SECTION 00 9113.02 - ADDENDUM #2

- A. Project Name: **Water & Sewer Building.**
- B. Owner: **City of Minot.**
- C. Architect: **Ackerman-Estvold, Engineering & Management Consulting, Inc.**
- D. Architect Project Number: **R25132.**
- E. Date of Addendum: **February 26th, 2026.**

ADDENDUM NO. C-1

STRUCTURAL ADDENDUM S-1:

SHEET
G300
ASSEMBLY TYPES

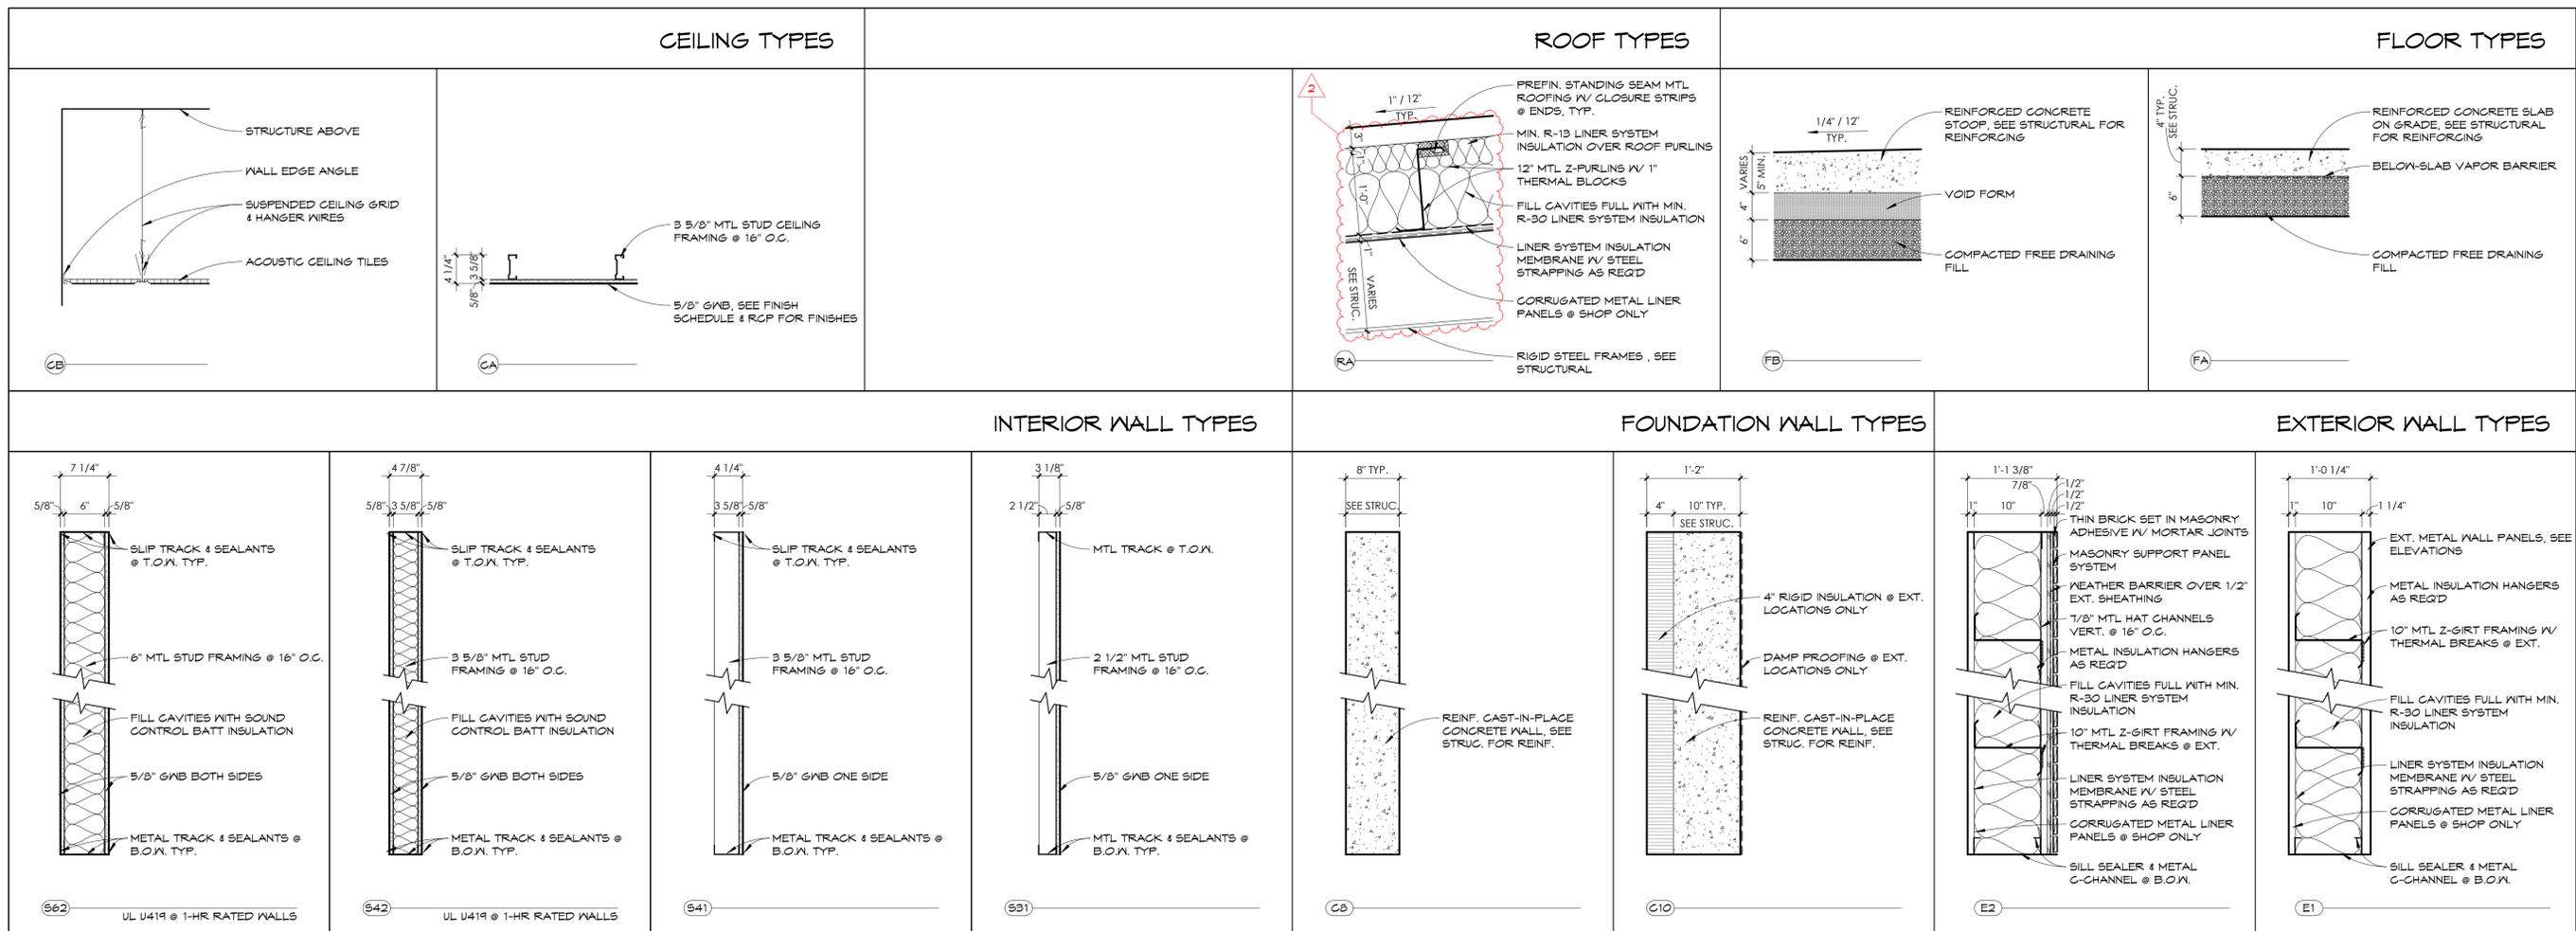
- A. Sheet G300 – Assembly Types (reissued).
 1. Roof Types: Clarified dimensions on graphics to match notes on roof type RA.
- B. Sheet A101 – Floor Plan (reissued).
 1. Drawing 1/A101: Add dashed lines indicating window treatments at the W2 window locations in the meter shop.
 2. Floor Plan General Note #3: Revise to read "Dashed line @ W1 & W2 windows..." In lieu of "Dashed line @ W1 windows..."
- C. Sheet iD100 – Finish Plans & Schedule (reissued).
 1. Room Finish Schedule: Omit "PAINT-2" notes for the soffits at rooms 101 & 102. Add Remark #2 for room 102.
- D. Sheet iD300 – Casework Details (not reissued).
 1. Drawing 19/iD300: Revise text below the "SA-3" note to read "Non-illuminated room plaque" in lieu of "non-illuminated acrylic room plaque."

SHEET
C401
 SITE PLAN

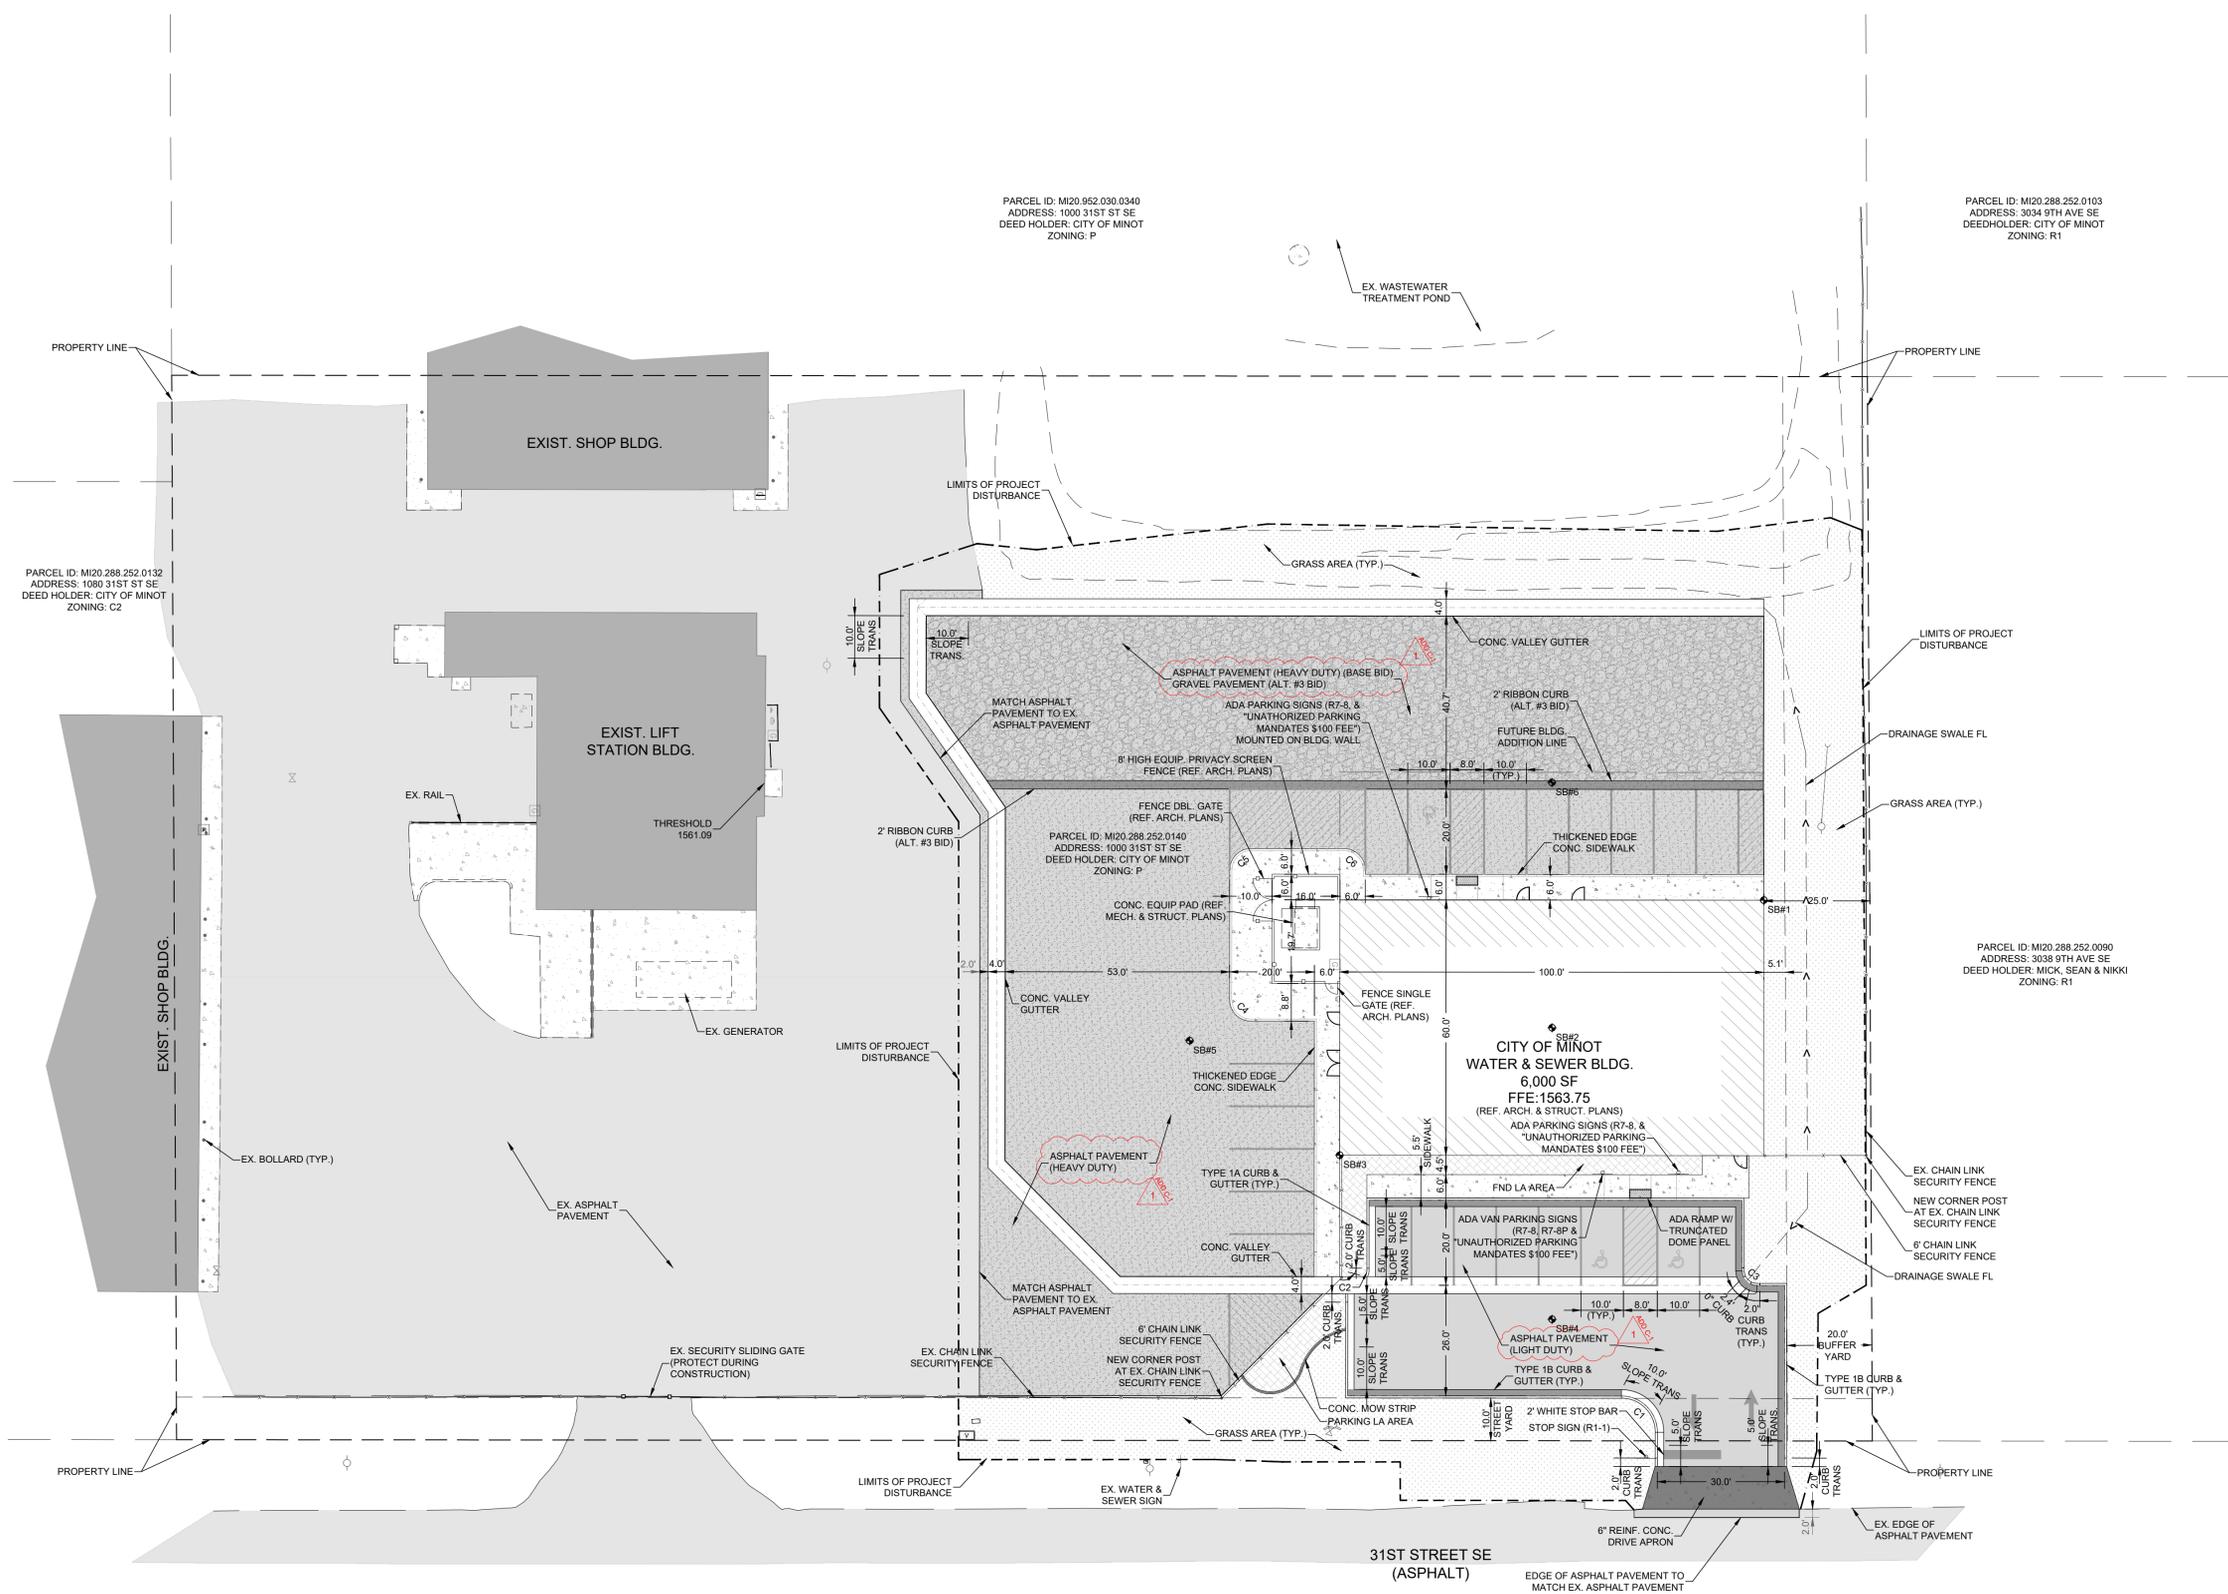
- A. Revised Pavement Legend.
- B. Asphalt Pavement – Heavy Duty section shall be installed behind the security fencing areas of the project.
- C. Asphalt Pavement – Light Duty section installed be installed at the public parking lot side of the project.

C501
GRADING PLAN

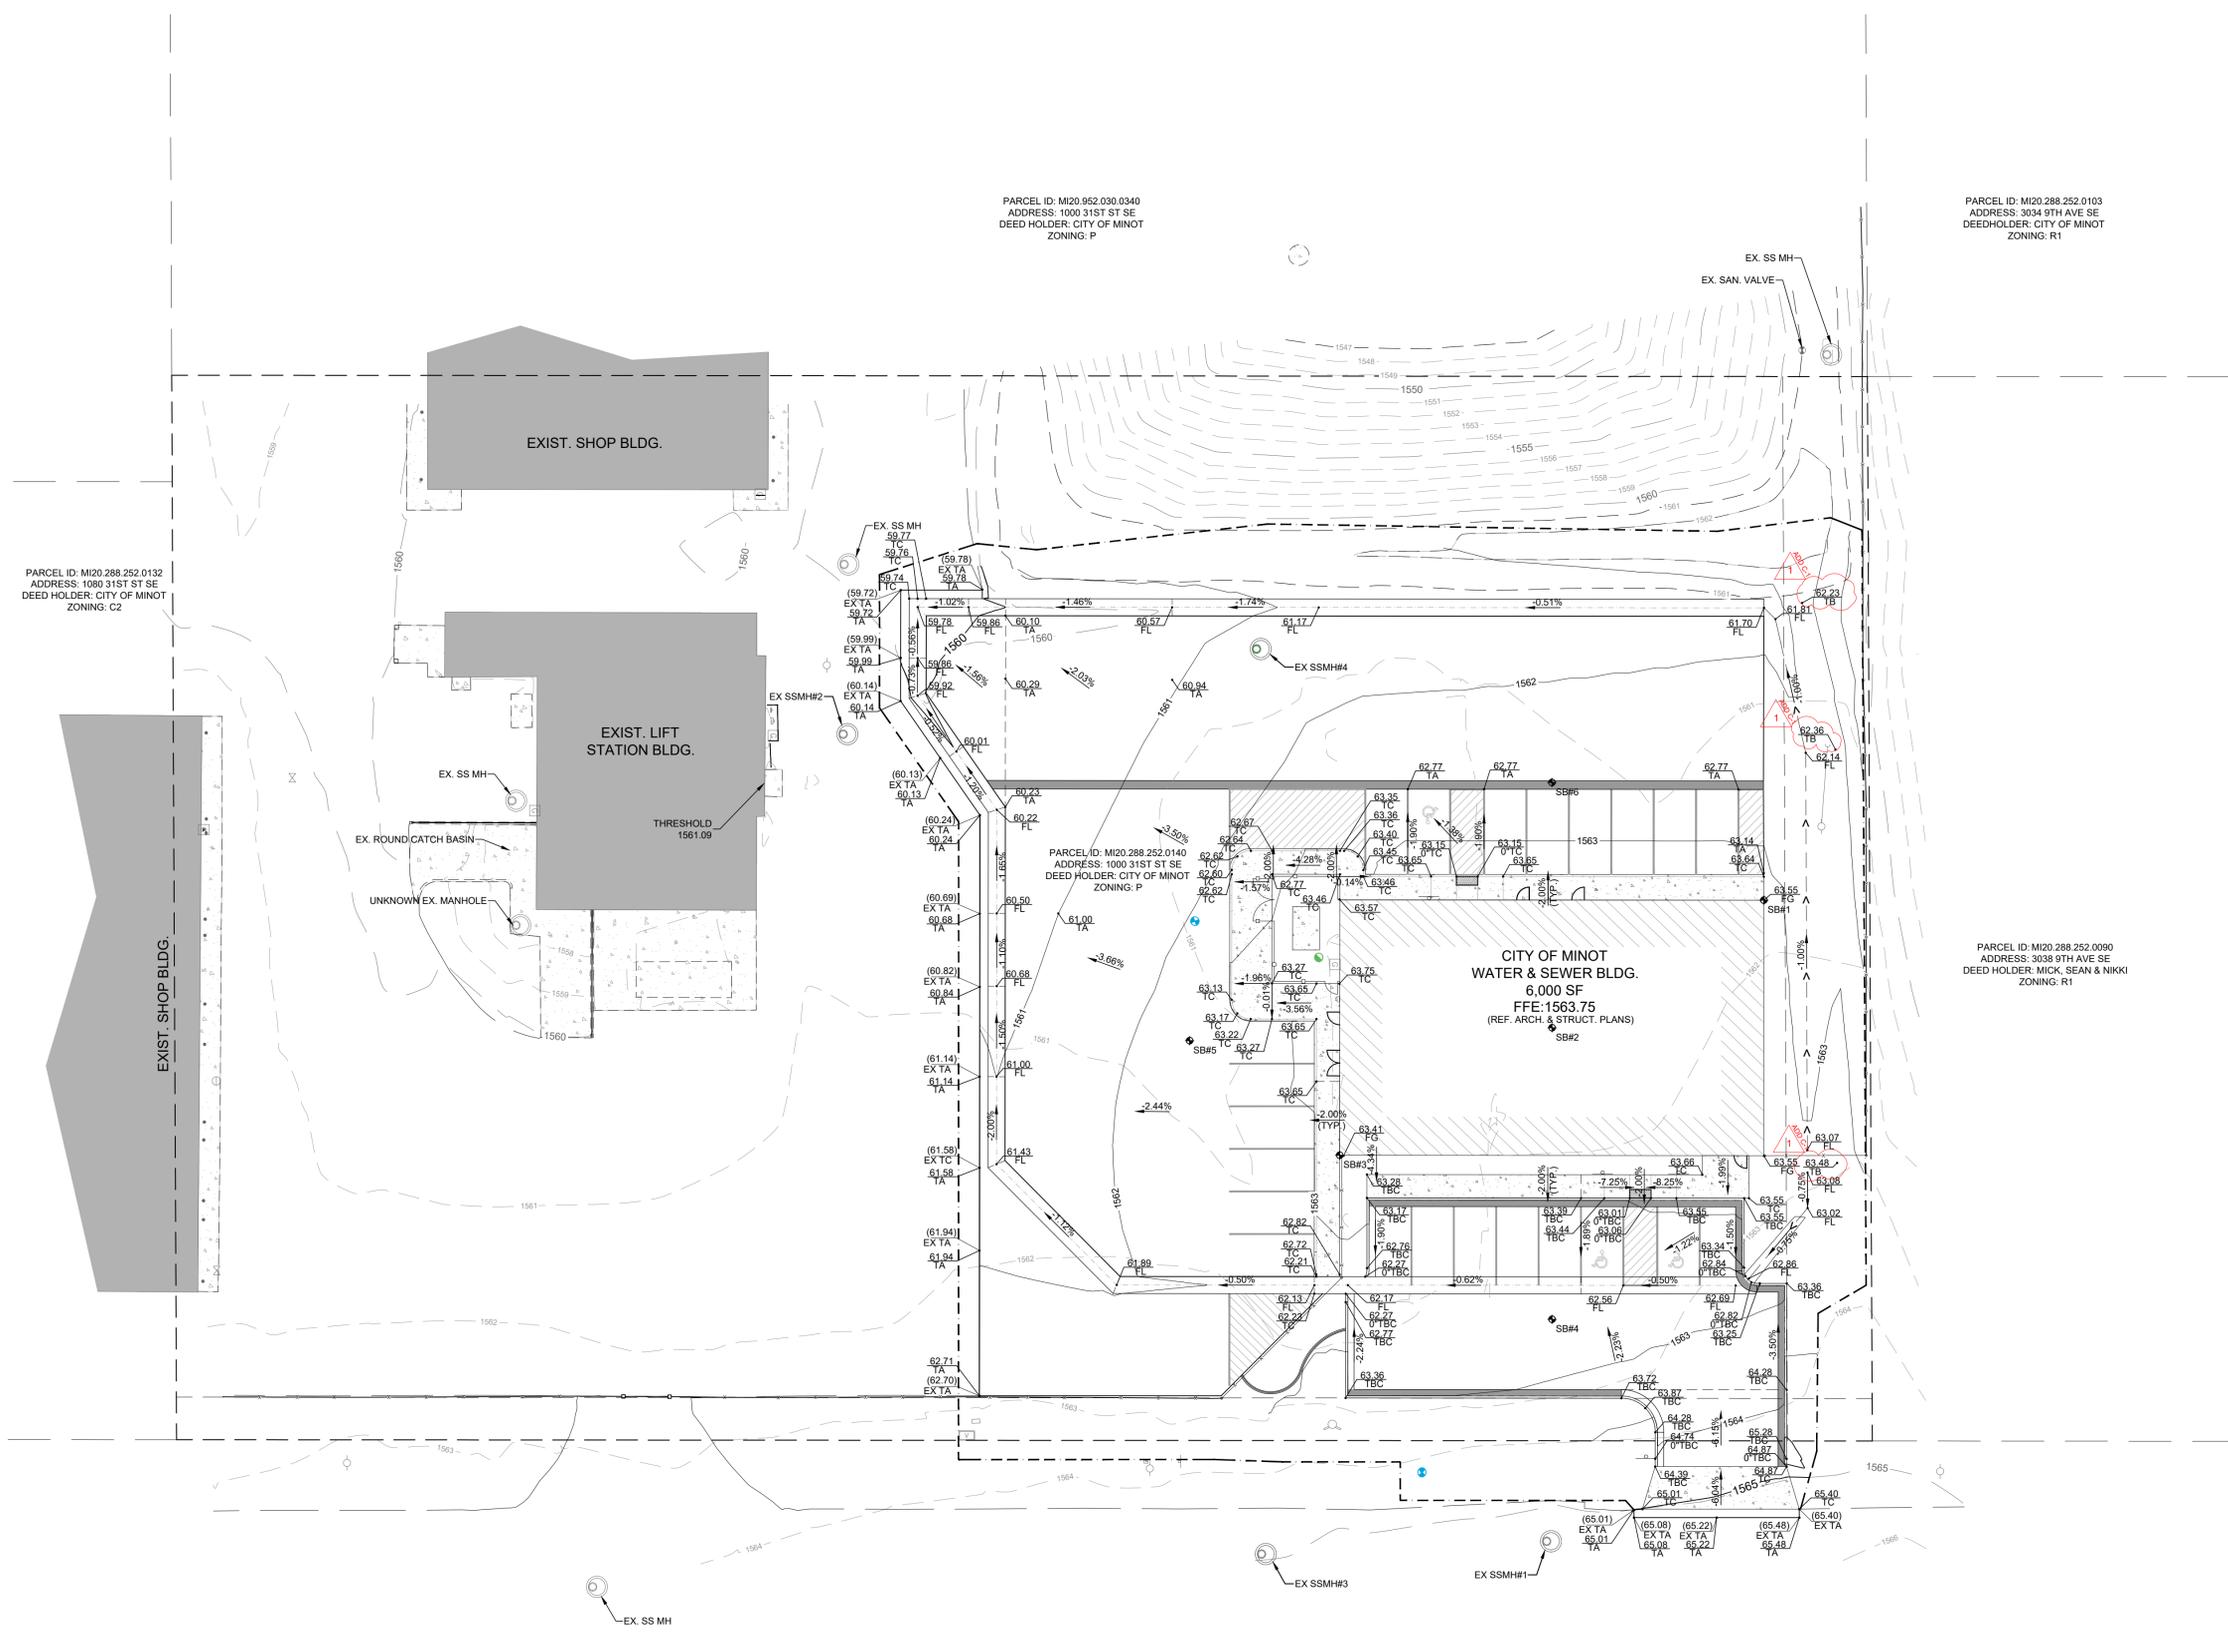
- A. Revised Grading Legend.
- B. Additional spot elevations at top of berm allow north property line.
